To: Members of Dublin City Council
From: Dana L. McDaniel, City Manager 
Date: January 5, 2017
Initiated By: Vincent A. Papsidero, FAICP, Planning Director
Jennifer M. Rauch, AICP, Planning Manager
Re: Basic Site Plan – Bridge Park West, Building Z2 – (Case#16-088ARB-BPR)

This is a request for review and approval of a Basic Plan Review for a mixed-use building including commercial and residential units with associated site improvements. The site is located east of North High Street, 180 feet north of the intersection with North Street. City Council is asked to review and make determinations on the Basic Plan applications in accordance with the amendments to the Bridge Street District (BSD) zoning regulations. Under these provisions, all projects involving development agreements require Basic Plan Review by City Council, who will then direct the review of the final Development Plan and Site Plan applications to City Council, the Planning and Zoning Commission, Architectural Review Board, or Administrative Review Team (as appropriate). This proposal for the Basic Plan Review includes seven Conditions and two Waivers.

2. BSD HTN – Bridge Street, Building Z2 16-088ARB-BPR 88 North Hi

SHEET
BSP6

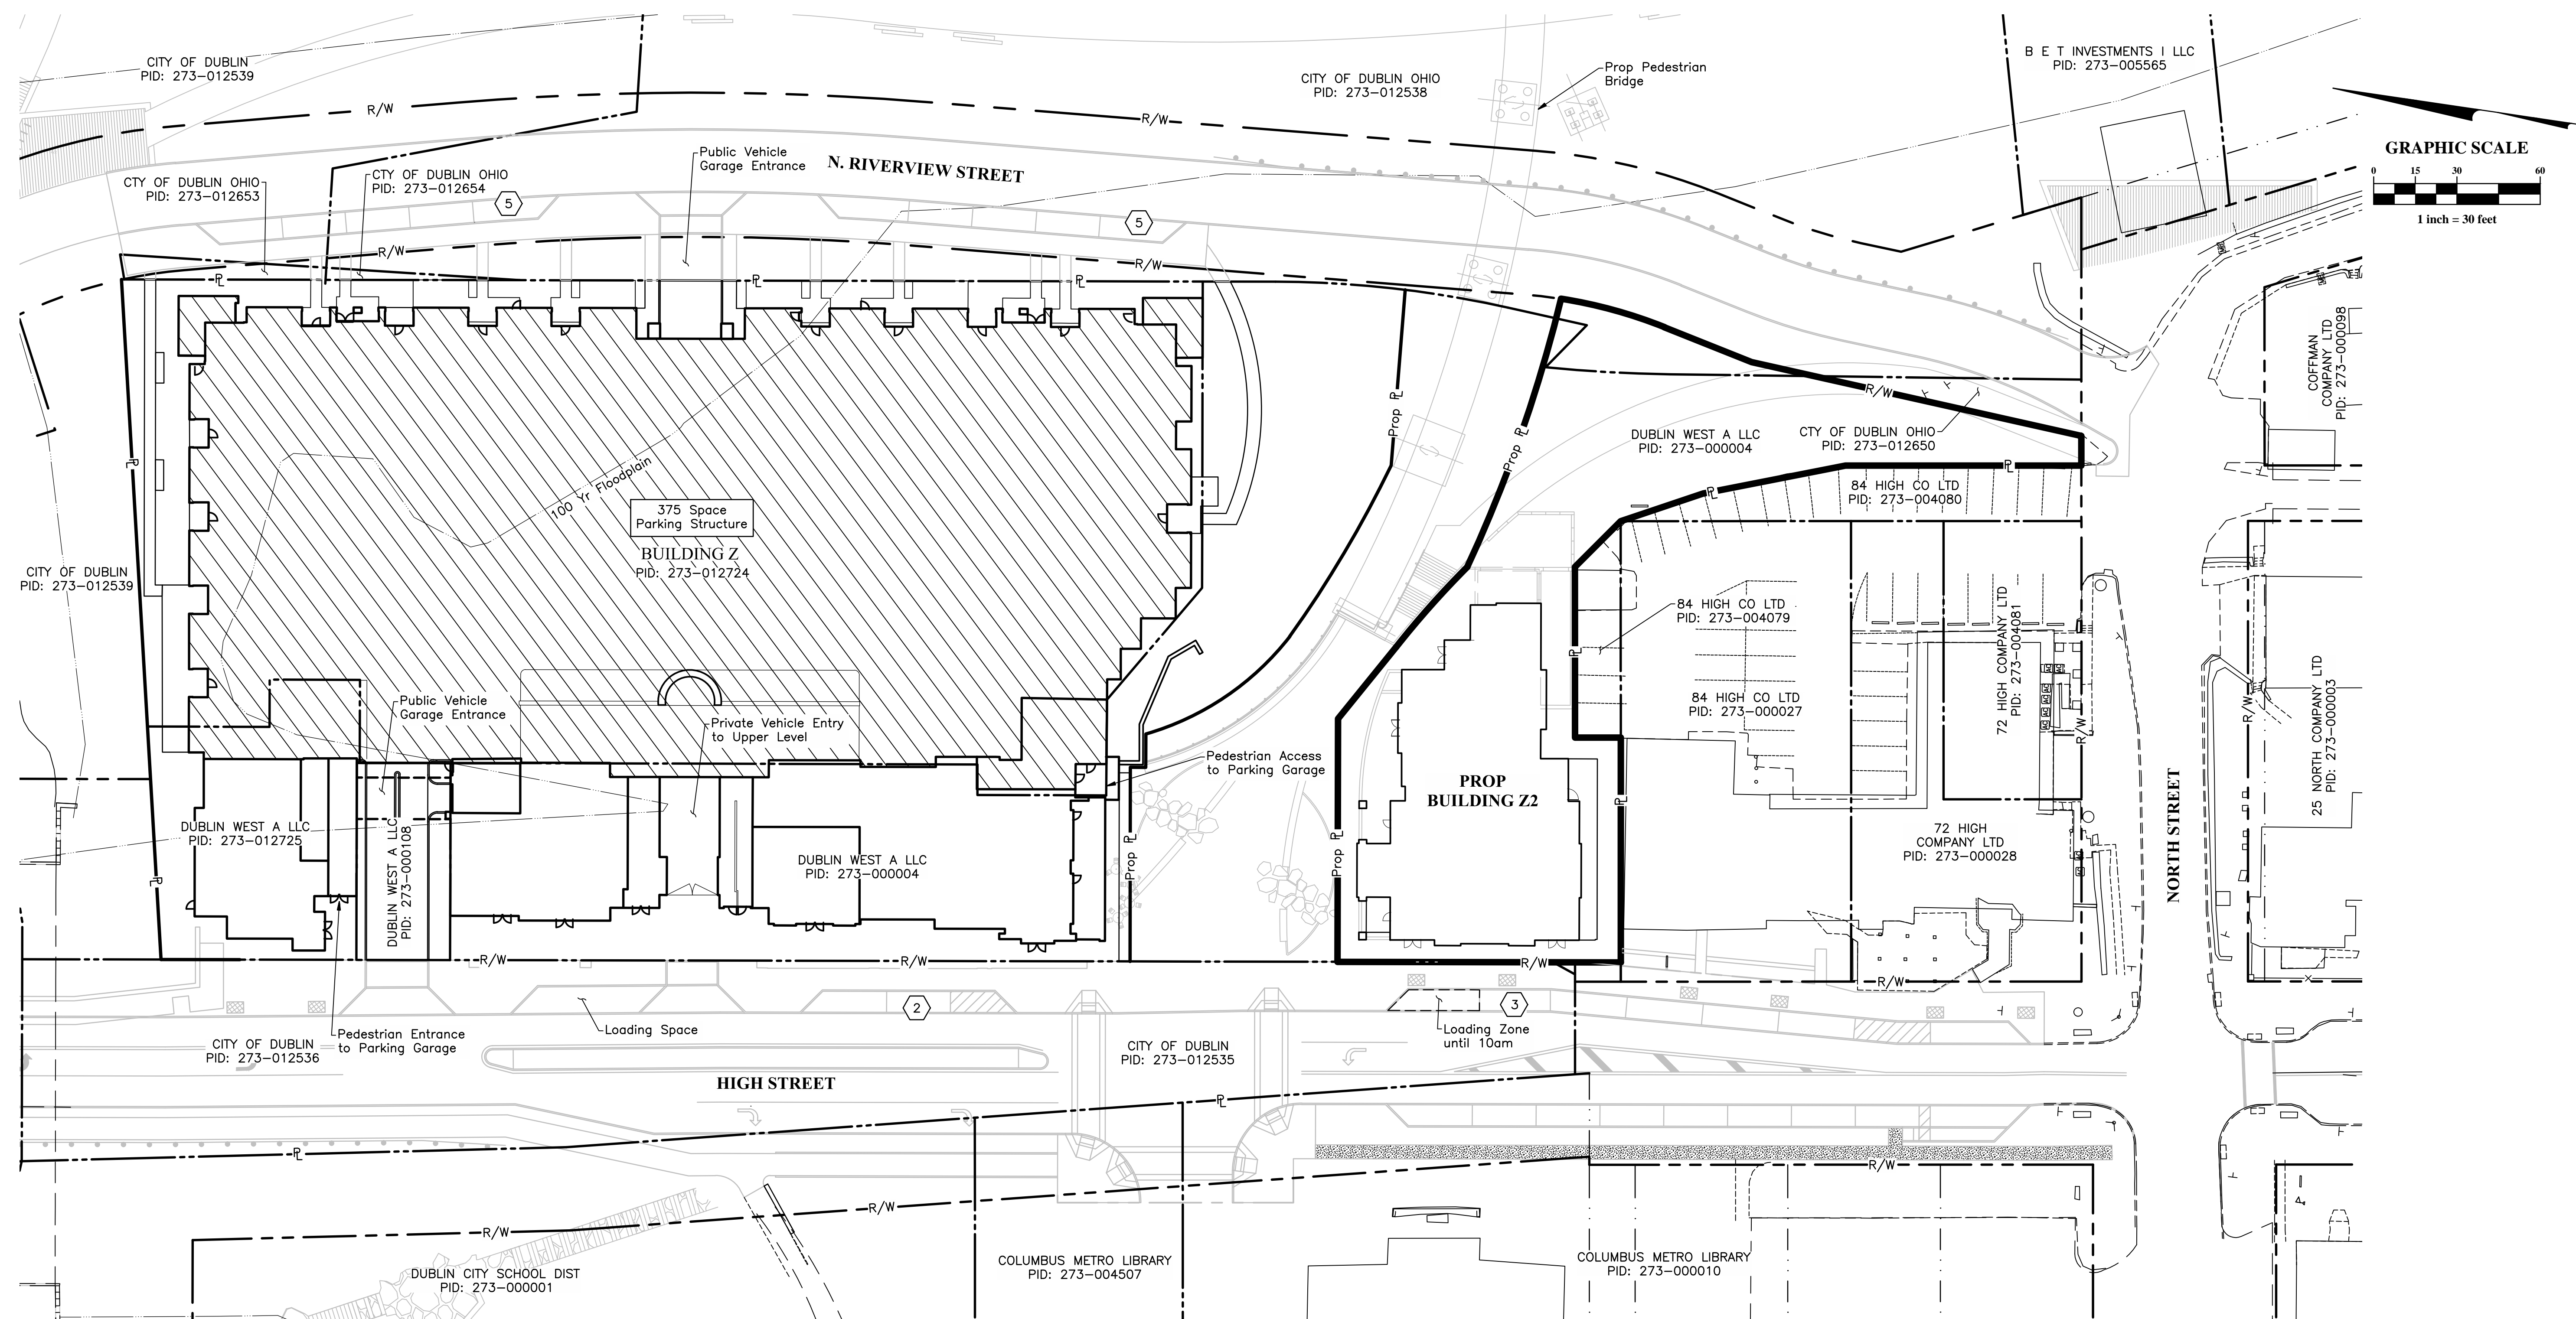
7. Final details regarding landscaping, lighting, utilities and stormwater will be required with the Site Plan.
- 2) Approve the two Waivers:
 1. Number of Building Stories

SHEET
BSP7

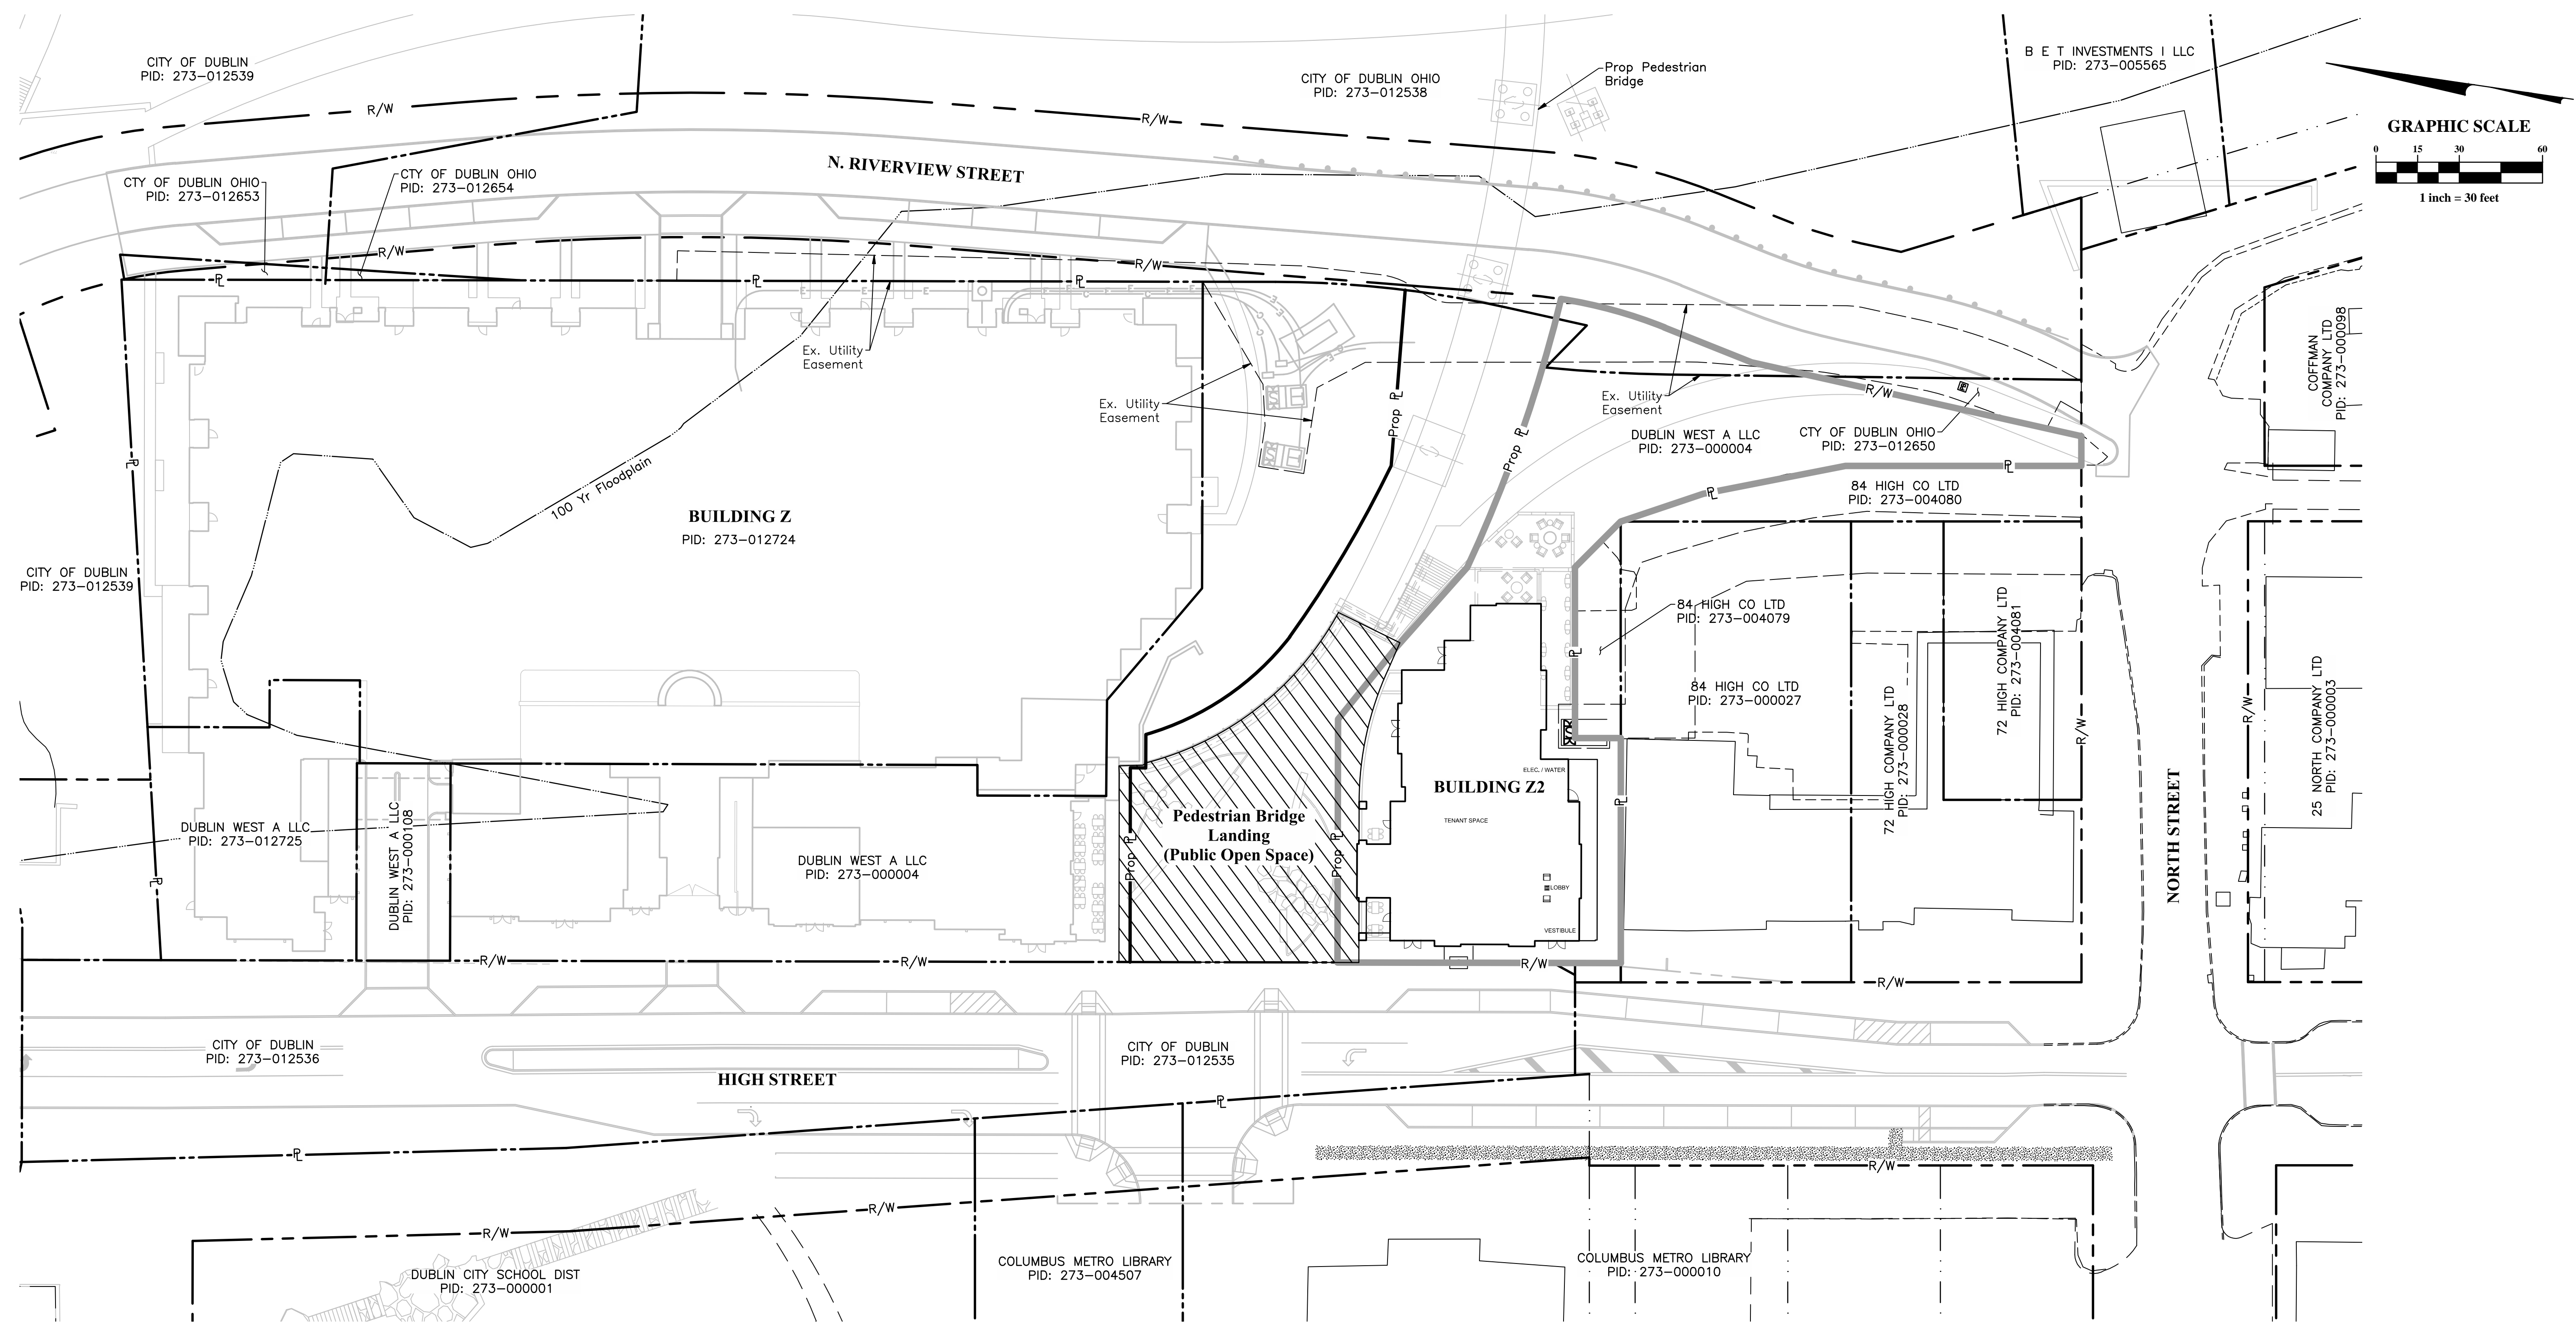
5. The applicant update the required parking information and submit a parking plan with the Site Plan.
 6. The open space, gateway and terminal vista details be addressed with the Site Plan.

| Details and Analysis | Basic Plan Review |
|---|---|
| <p>Circulation and Parking</p> | <p>The approved plans for Building Z indicated the provision of 360 structured parking spaces inside the parking garage and 12 on-street spaces. The number of parking spaces required for the uses in Building Z total a minimum of 249, which include the 141 for the commercial uses and 105 private parking spaces for the residential units. The proposed parking intended for the residents and patrons of the Building Z2 will be provided with the Building Z garage. The proposed plans indicate 87 parking spaces are required for Z2, which can be met with the Building Z garage. The number may change due to the discrepancies in the square footages within the plan set and will need to be verified at Site Plan Review. Additionally, a parking plan will be required as parking is proposed off-site.</p> |
